Document Update Notification

DOCUMENT NO: OP-1903.033

TITLE: PROTECTIVE ACTION GUIDELINES FOR
RESCUE/REPAIR & DAMAGE CONTROL
TEAMS

REVISION NO: 018-00-0

Attachment 2

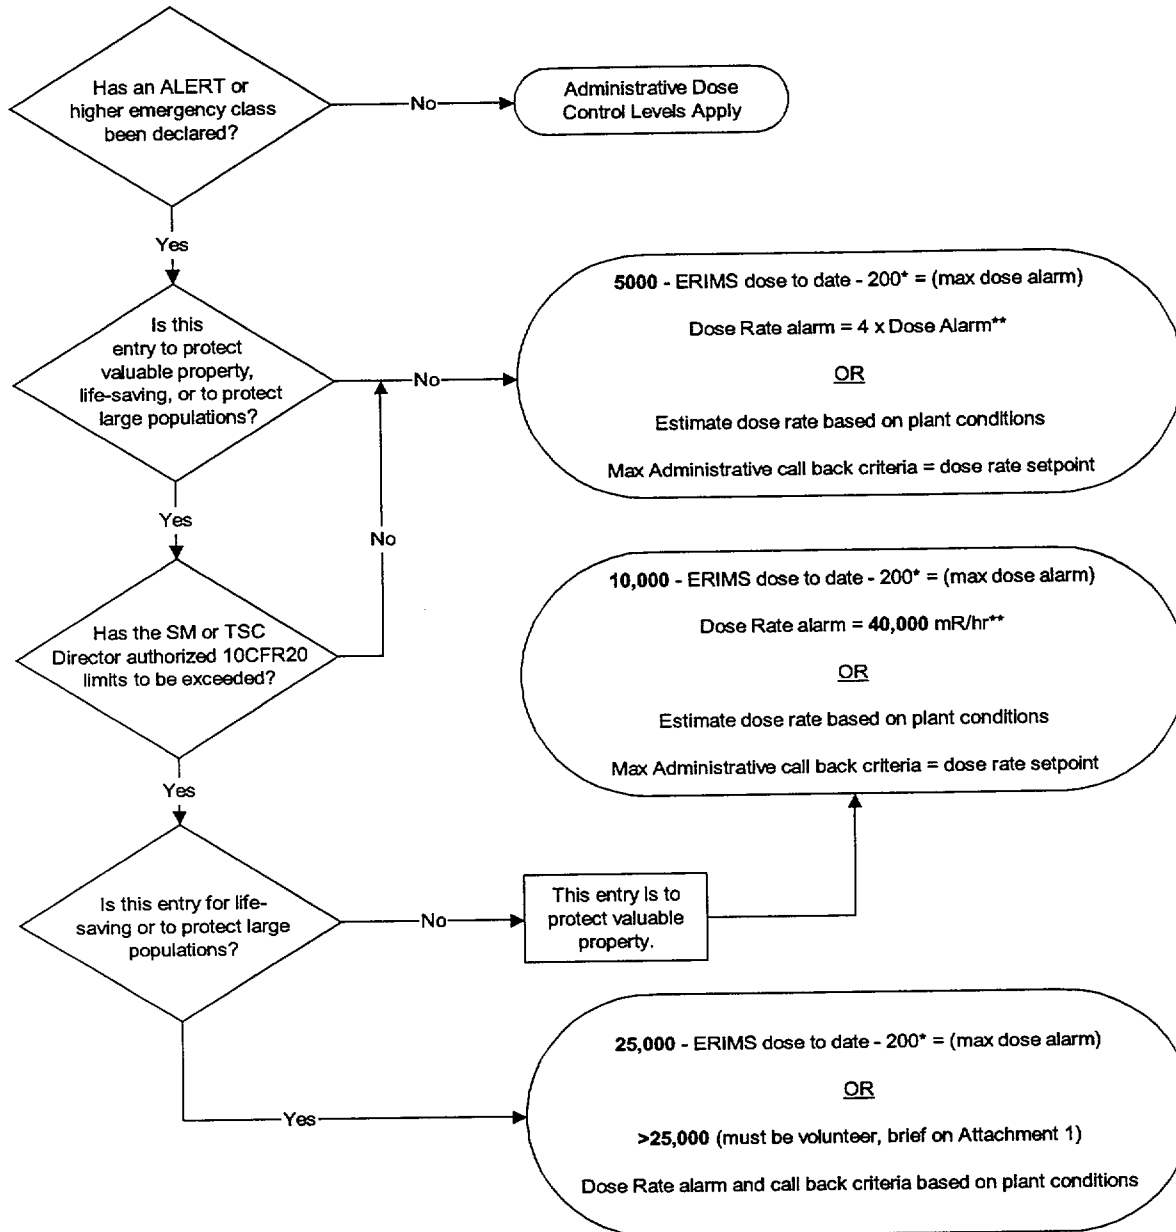
4.1, 5.1, 5.8, 6.1.1, 6.2.2, 6.2.3.E, 6.2.3.F.3, 6.2.4.A, Attachment 2	Changed Shift Superintendent to Shift Manager
6.1.3	Re-worded for clarity and changed Shift Superintendent to Shift Manager
